SUPPLEMENTAL INFORMATION

HOOD PARK MASTER PLAN

NOVEMBER 21, 2018

1.0 SUPPLEMENTAL INFORMATION FILING

Figure 1-12
 Proposed Areas, Uses and Zoning Heights

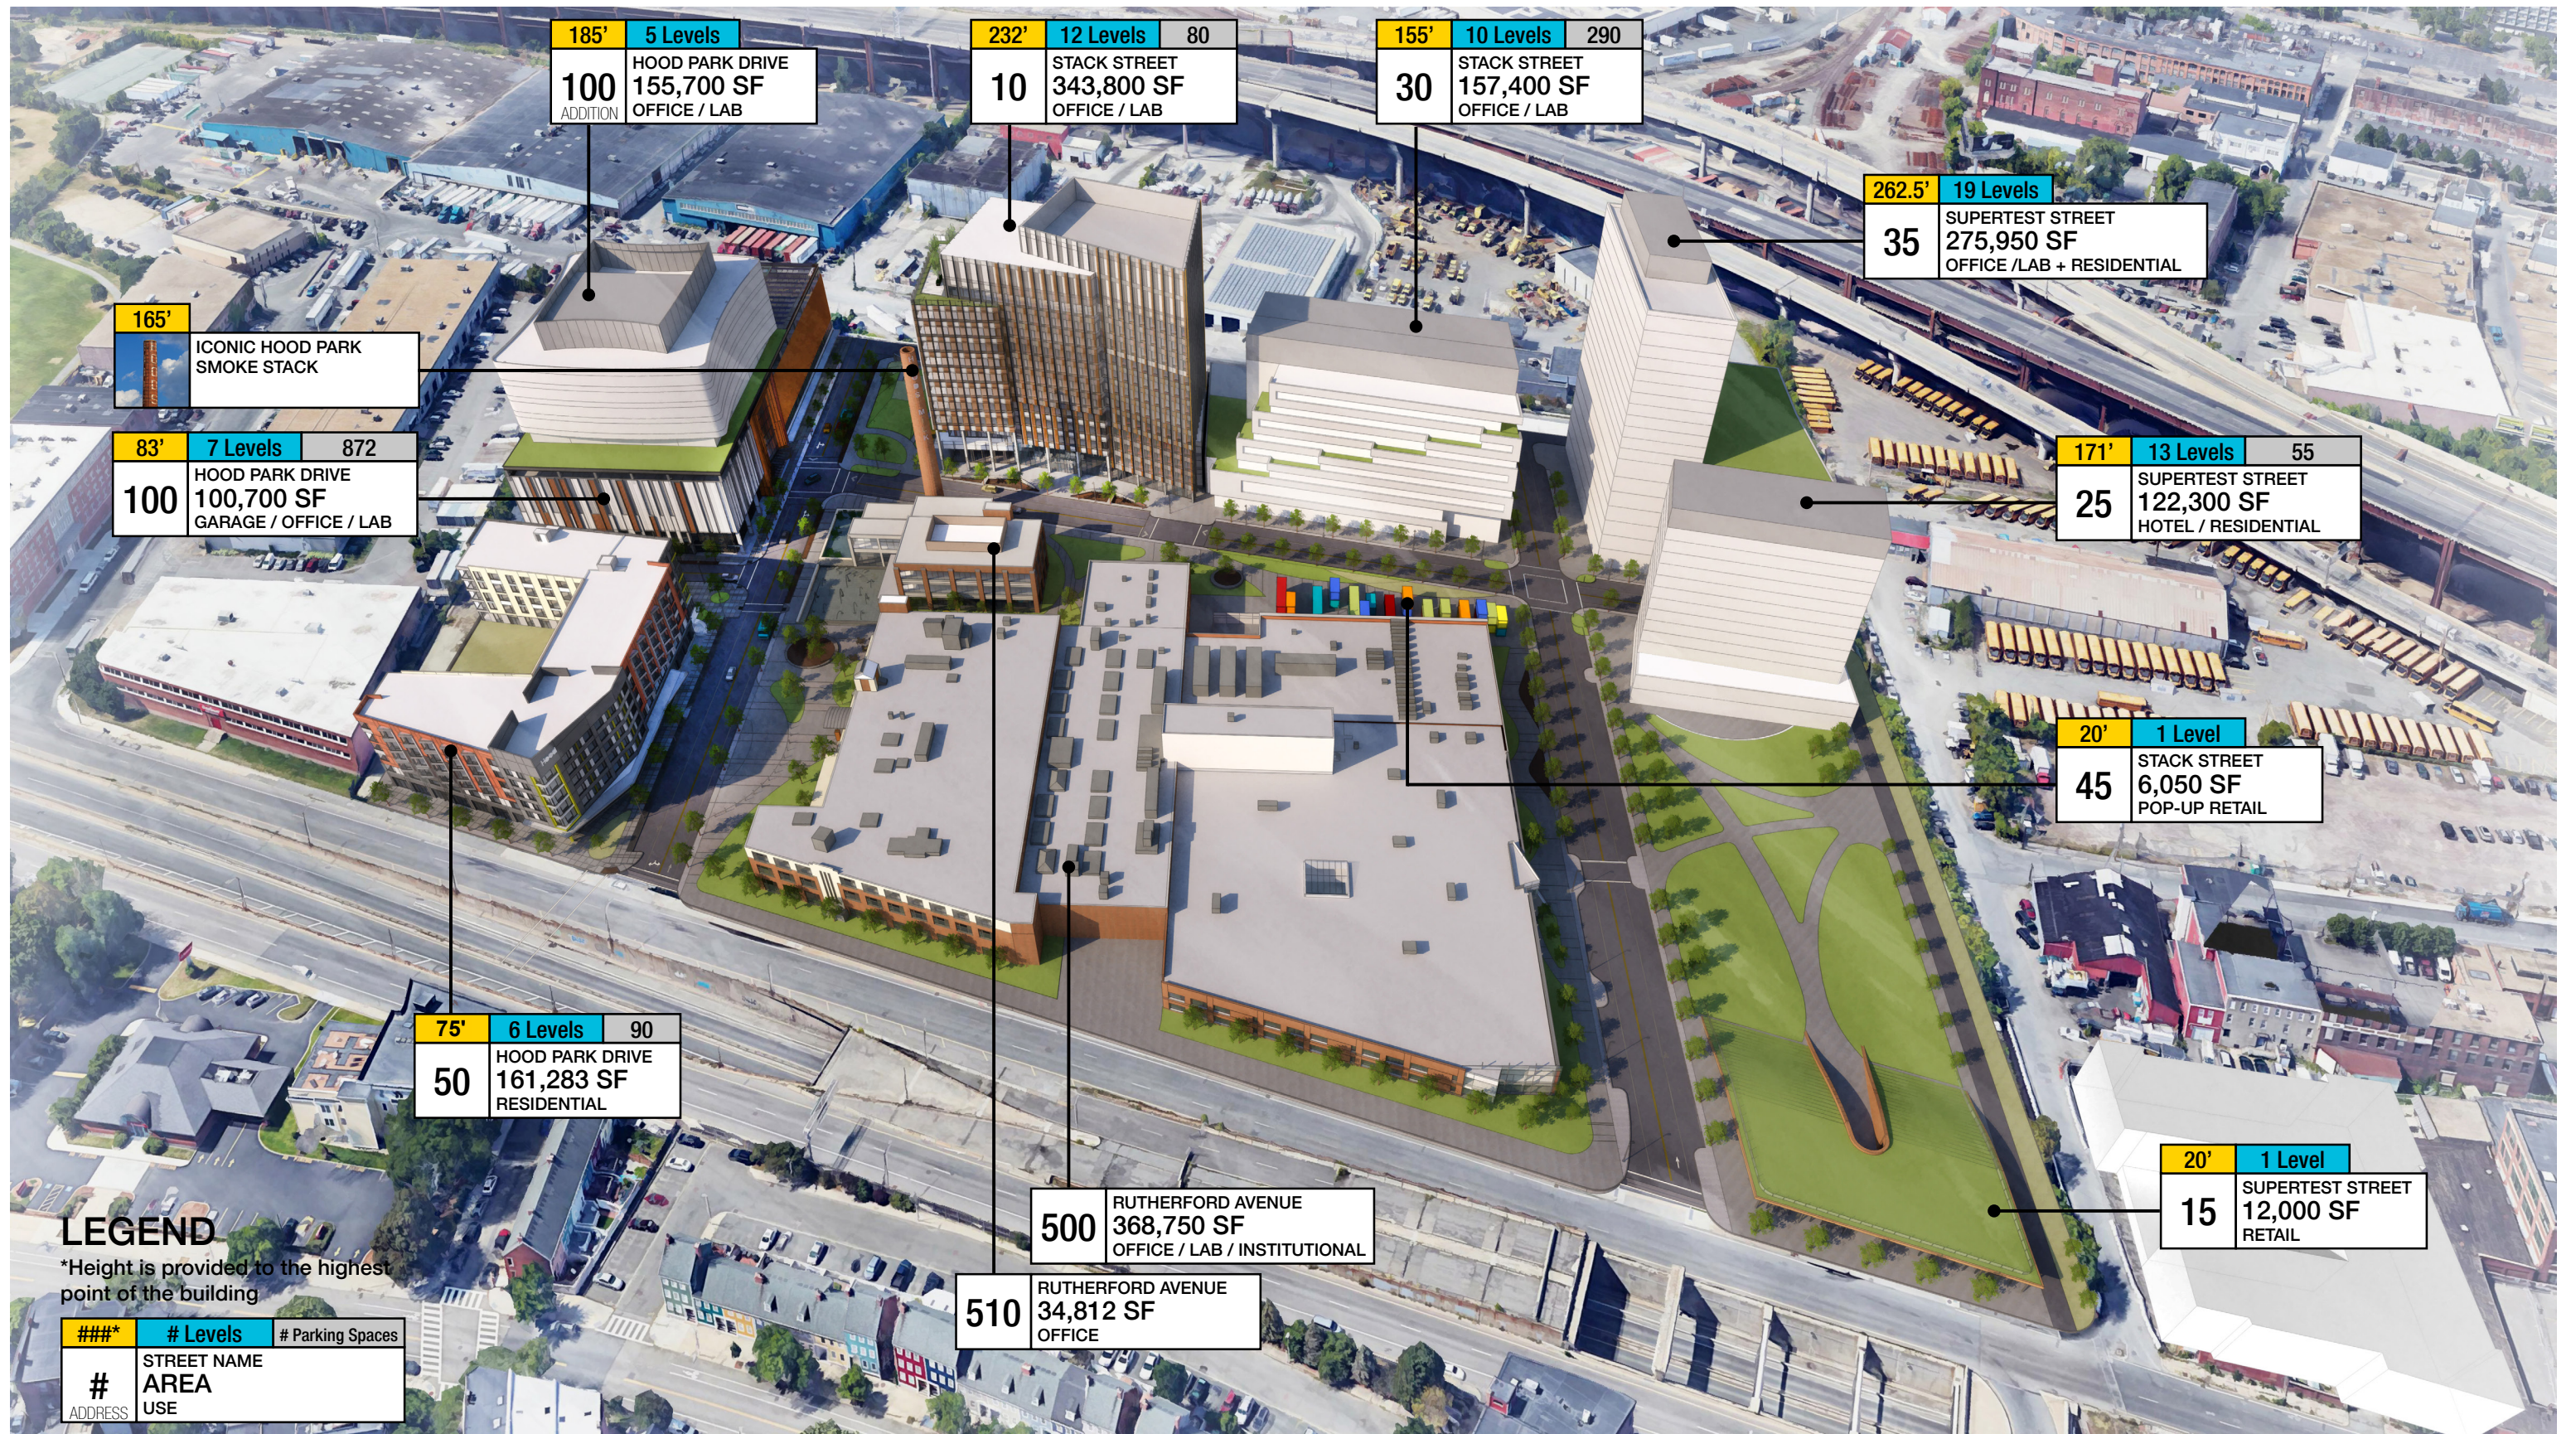
- 1) 35 Supertest will be reduced in height to 262.5 feet and reduced in area to 304,700 square feet. In order to accomplish the height reduction, in part, the Proponent is eliminating the above grade parking use previously contained on levels 3 through 5 in this building.
- 2) 30 Stack Street will be increased in height to 155 feet and increased in area to 157,400 square feet.
- 3) 10 Stack Street will have one level of below grade parking rather than the previously proposed two levels and will therefore have a reduced parking count of 80 spaces.
- 4) 100 Hood Park Drive will remain at the previously proposed height; however, the initial construction effort will increase to 100,700 square feet of area and the proposed addition will increase to 155,700 square feet of area. The parking count in the garage will be reduced to 872 spaces.

The above revisions, and a complete summary of the proposed components of the project are provided in detail in the below Revised Table 1-2 and Figure 1-12.

The Proponent is pleased to submit the above Revised Table 1-2 and below Revised Figure 1-12 to the BPDA and Charlestown community for review and comment as part of the ongoing Article 80 process. The Proponent believes that the lowered height will be perceived as a positive response to community comments regarding the project, resulting in reduced shadows and visual impact on the neighborhood. The reduced parking capacity should also be perceived as a positive effort to discourage vehicle commuting to Hood Park resulting in reduced traffic impacts in the Sullivan Square area. Finally, the relocation of the square footage from 35 Supertest Street to other buildings on campus does not result in any increase in density or traffic as it results in the same FAR of 2.0 as previously proposed.
